ITEM: PLAN COMMISSION FILE NO. 2009 – Banchory Woods Subdivision: Request for Final Plat of Subdivision approval with certain public improvements/ infrastructure exceptions from Code

DATE: February 4, 2004

**A RESOLUTION APPROVING THE FINAL PLAT OF
SUBDIVISION FOR THE BANCHORY WOODS SUBDIVISION
INCLUDING REQUIRED PUBLIC IMPROVEMENT EXCEPTIONS**

TO: Joseph P. Skach, AIA, AICP, Director of Planning & Community Development
FROM: David H. Barber, P.E., Director of Public Works
BY: Michael D. Millette, P.E., Asst. Director of Public Works – Engineering *MDM*
Jonathan C. Hall, P.E., Development Engineering Manager II
DATE: January 9, 2004
RE: Planning / Zoning Petition for Final Plat of Subdivision
Banchory Woods – Joel Andersen Homes
Public Works Department **3rd Review**

DRAWN BY: JRE	CHECKED BY: BLH	
SCALE: 1"=30'	DATE: 9-09-03	
JOB NUMBER: 03-145	SHEET: 6 OF 13	
#	DATE	DESCRIPTION
1	10-10-03	PER VILLAGE OF DOWNS GROVE
2	11-05-03	PER I.L.C. PUBLIC WORKS DEPT.
3	11-26-03	PER VILLAGE OF DOWNS GROVE
4	01-06-04	PER VILLAGE OF DOWNS GROVE
5		
6		
7		
8

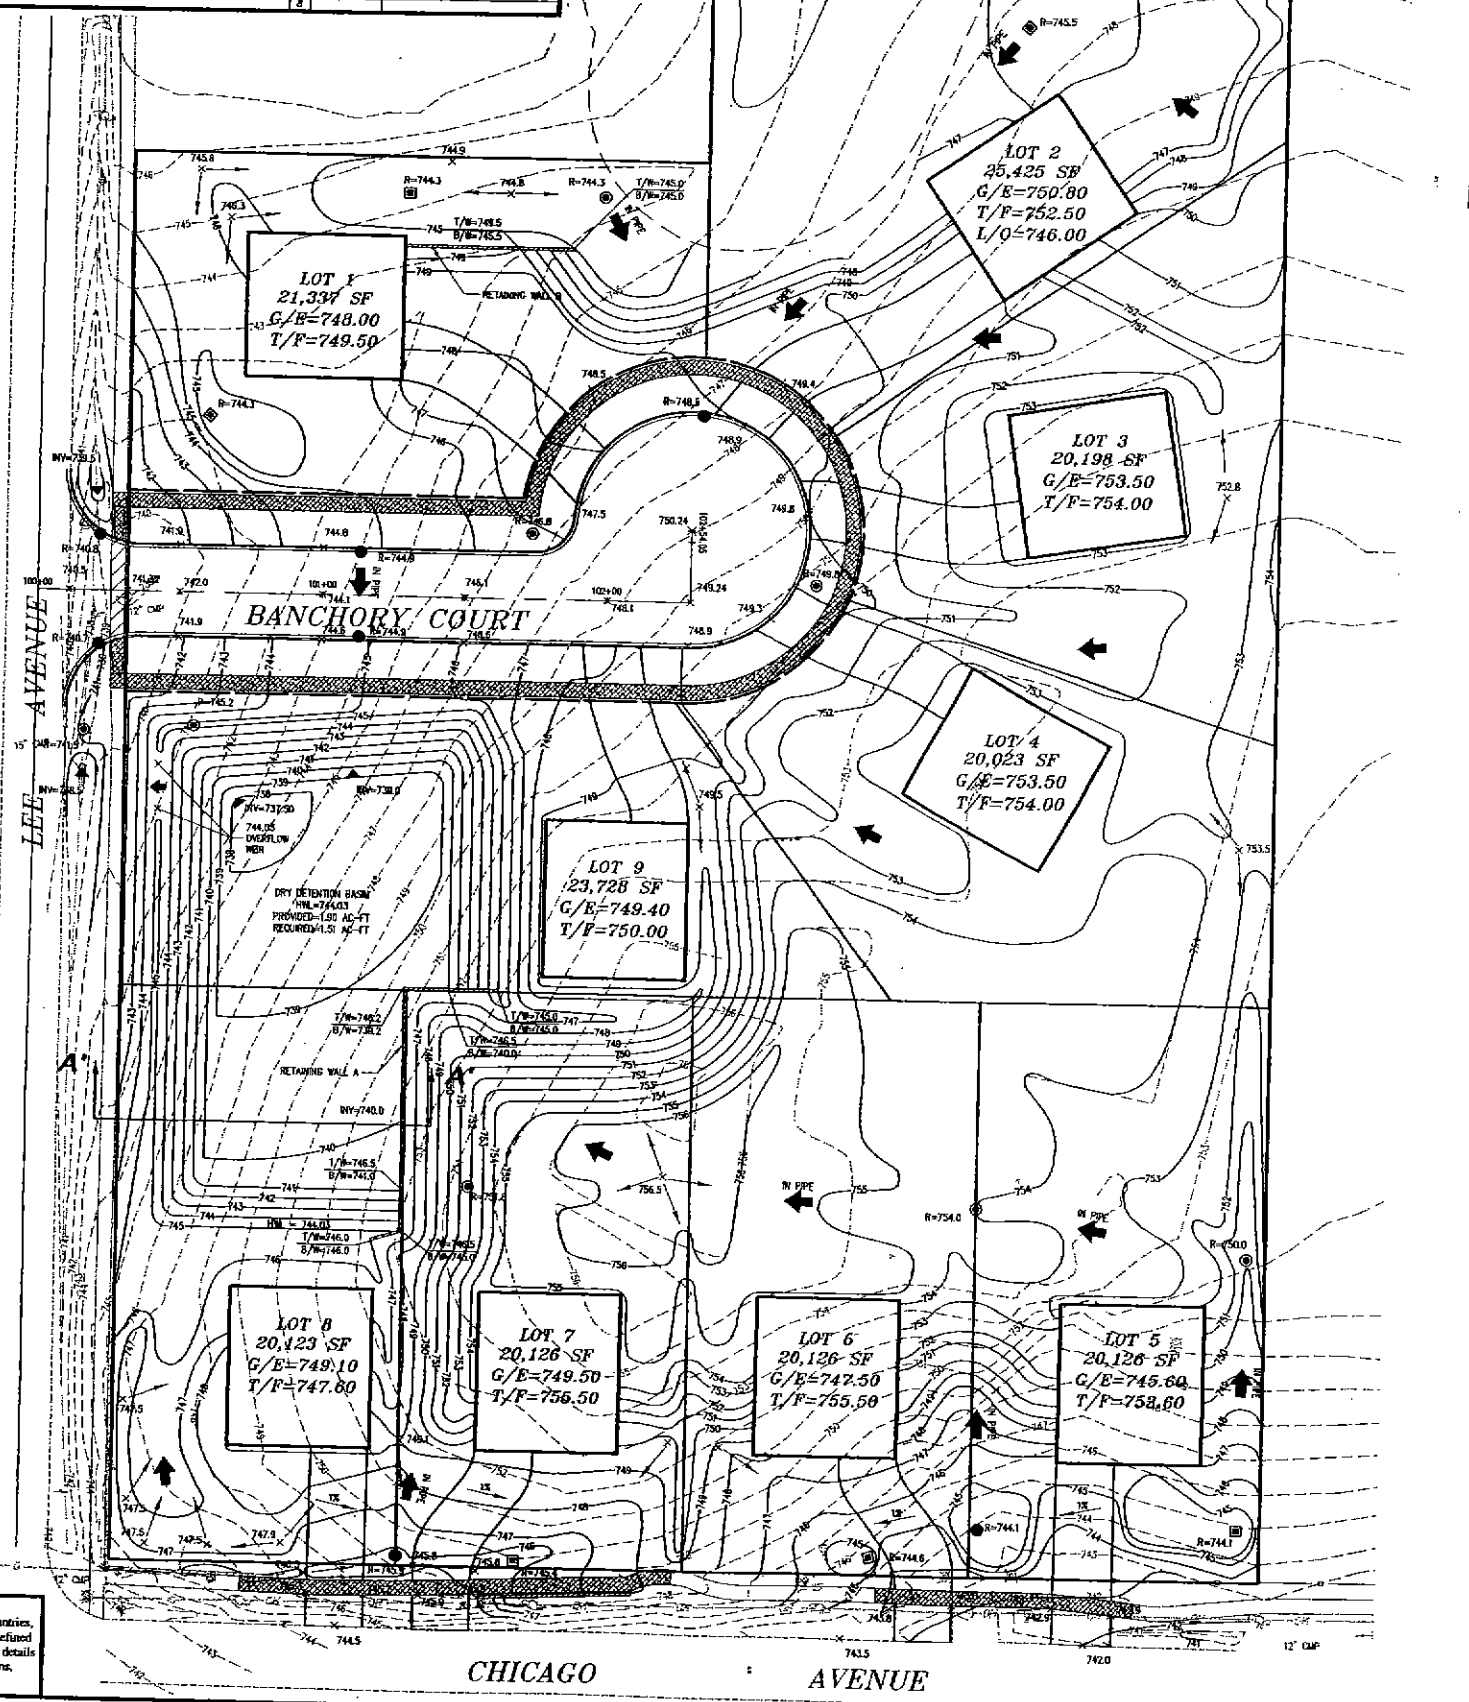
- Based upon proposed contouring, almost the entire south frontage of Chicago will have to have sidewalk replaced. **Resolved**
- Show estimated square foot face of affected retaining wall at southwest corner of Chicago and Lee due to regrading. **Completed**

- Show estimated new square foot face retaining wall to be installed Chicago. Ideally, this wall should be moved to North side of walk to minimize tree root disruption, or placed perpendicular to walk at dripline (assuming parkway tree is to be saved). **Resolved** Slight shifting of walk provided enough clearance so wall could be place as originally planned.

REMOVE AND REPLACE 725 SF OF CONCRETE SIDEWALK
EXISTING UTILITY POLE TO BE PROTECTED DURING CONSTRUCTION
PROPOSED MODULAR FLOOR RETAINING WALL 120 SF
REMOVE AND REPLACE 450 SF OF CONCRETE SIDEWALK
EXISTING 12" CUP PCC SIDEWALK
